**Re: DC/25/99436 At 111 WINCHESTER ROAD, CHANDLER'S FORD,  
EASTLEIGH, SO53 2GH**

**Discharge of conditions 3 (Construction and Environmental Management Plan), 4 (Acoustic Design), 5 (Materials) and 7 (Cycle Storage Details) of application PN/24/97626 (Application for Prior Approval for a single storey roof extension to form 5 apartments, under Schedule 2, Part 20, Class AB of the Town and Country Planning General Permitted Development Order) permitted 16th August 2024.**

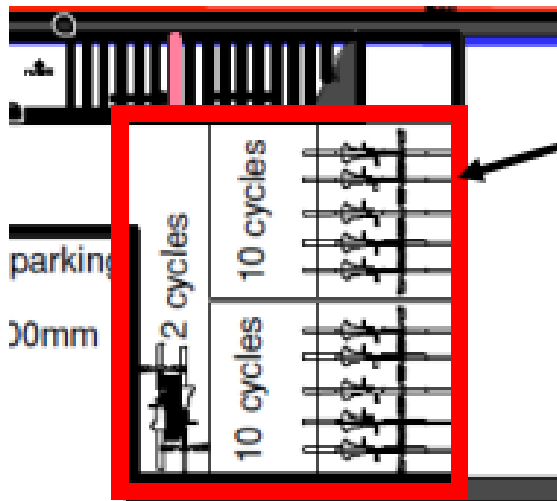
Onwards, details of the internal layout of the cycle store have been provided by the Case Officer, and this utilises a double layered row of 10 cycle parking spaces (20 cycle parking spaces in total) plus a single Sheffield Stand which can provide secure parking for a further 2 cycles.

However, whilst as outlined above there is no objection to these proposals from a highway perspective, as a point to note, the top layer of the double rack does of course require space in which to pull the cycle down and push it up again for storage. Due to the position of the Sheffield stand, the end 8 spaces (two rows of 4) will be tight for manoeuvring the cycles on and off of the rack.

The Case Officer may wish to review this, and potentially request that the Sheffield Stand is removed, and replaced with two single wall mounted cycle parking brackets or similar. This would provide additional width in which to manoeuvre from the top row spaces in particular.
